August 13, 2021

Re: *E202179*

This letter is in response to requests from the Federal Communication Commission to provide supplemental information with regard to the earth station application referenced above. Specifically, the Commission requested the following information:

Figure 1: PFD Contour with county boundaries and distance/mileage scale

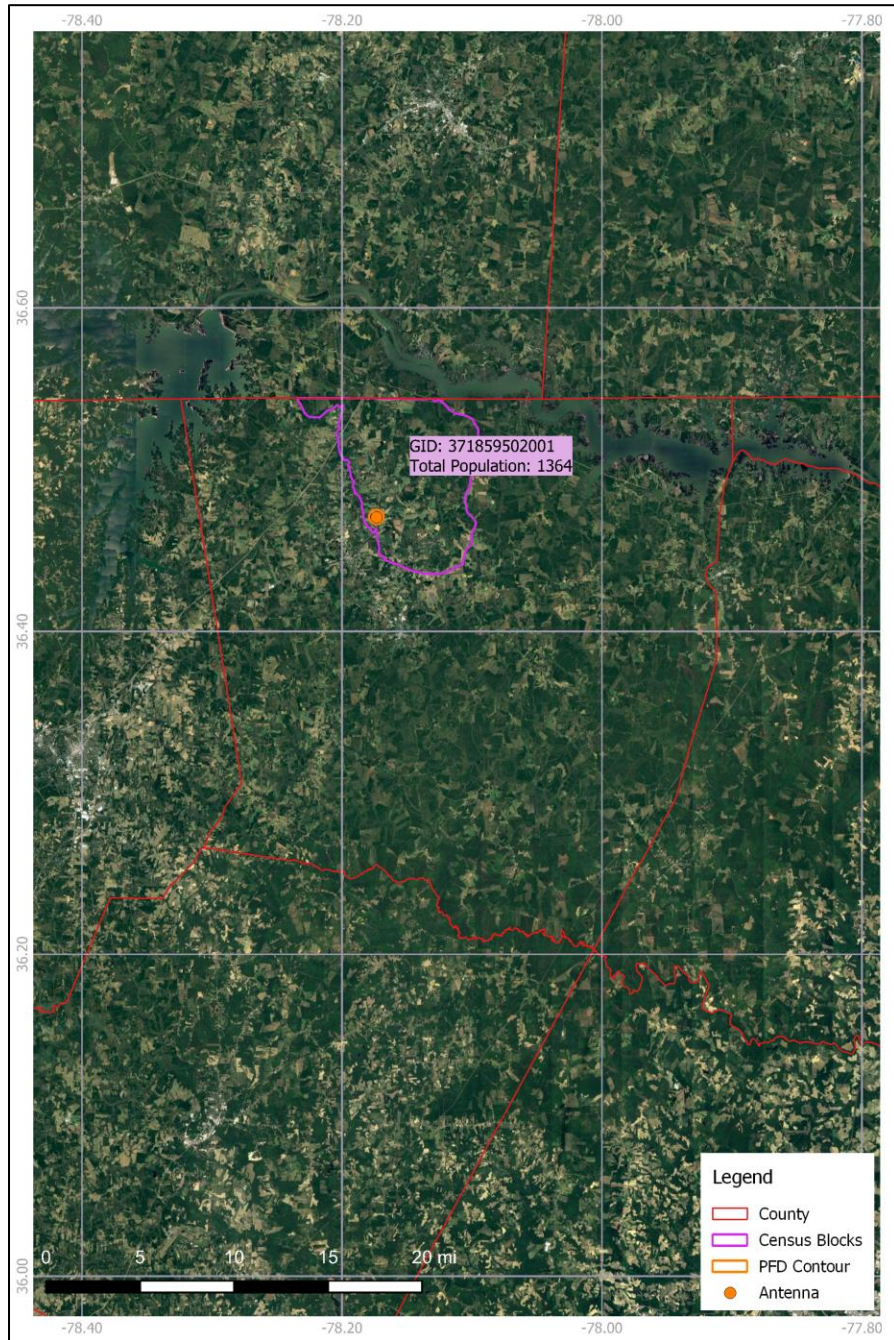
1) Addition of county boundaries and distance/mileage scale to PFD contour plots

In accordance with 47 CFR § 25.136(a)(4)(ii) and 47 CFR § 25.136(a)(4)(iii), county boundaries and map legends with distance/mileage scale for measuring the relative size of the proposed PFD contour are included as Figures 1-3 in the appendix of this document. The size and shape of the PFD contour in these figures differs from that of the initial license application for the following reasons:

- Change in antenna sidelobe levels; see section 6 of this pleading for detail
- Addition of clutter assumptions; see section 7 of this pleading for detail

Due to the aforementioned changes, this earth station will no longer require shielding to comply with 47 CFR § 25.136.

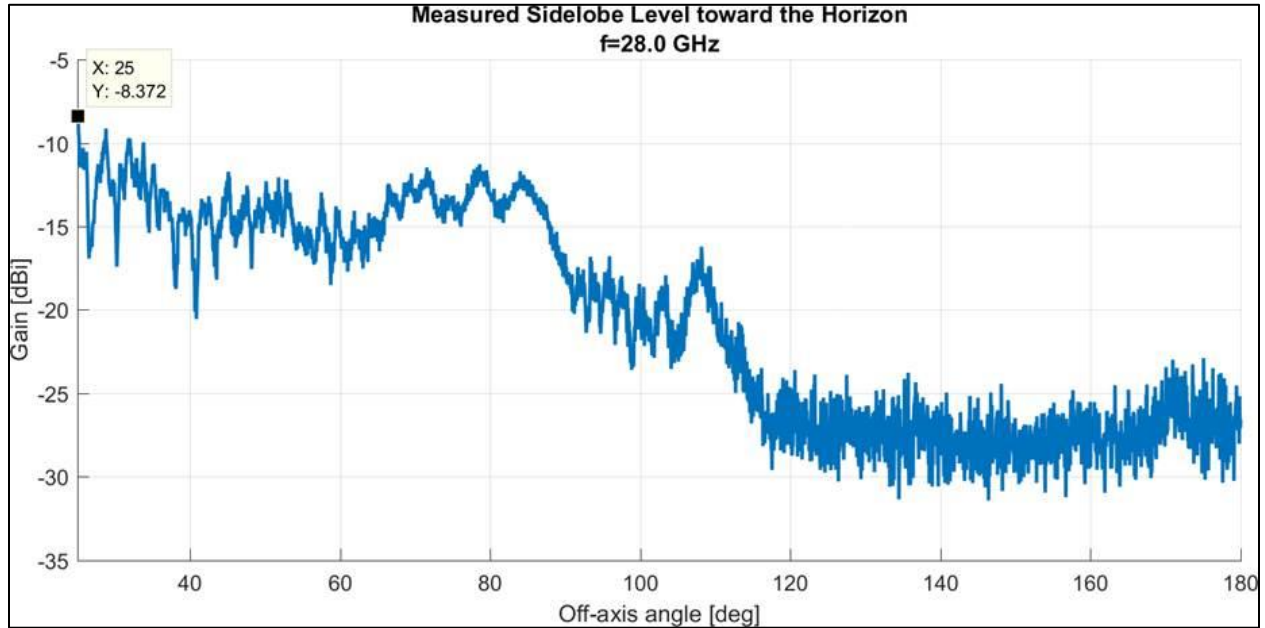
6) Explanation of changes in antenna sidelobe levels

While the analysis and PFD contours provided with the initial license application for this earth station (filed 10/16/2020) feature an antenna sidelobe level towards the horizon of -1 dBi, the analysis and PFD contours submitted with this pleading feature an antenna sidelobe level towards the horizon of -8 dBi.

For the reasons explained above, an antenna sidelobe level towards the horizon of -8 dBi is a more accurate representations of reality for this earth station than the value of -1 dBi that was previously used. See appendix Figure 4 for detail on antenna sidelobe measurements and related methodology.
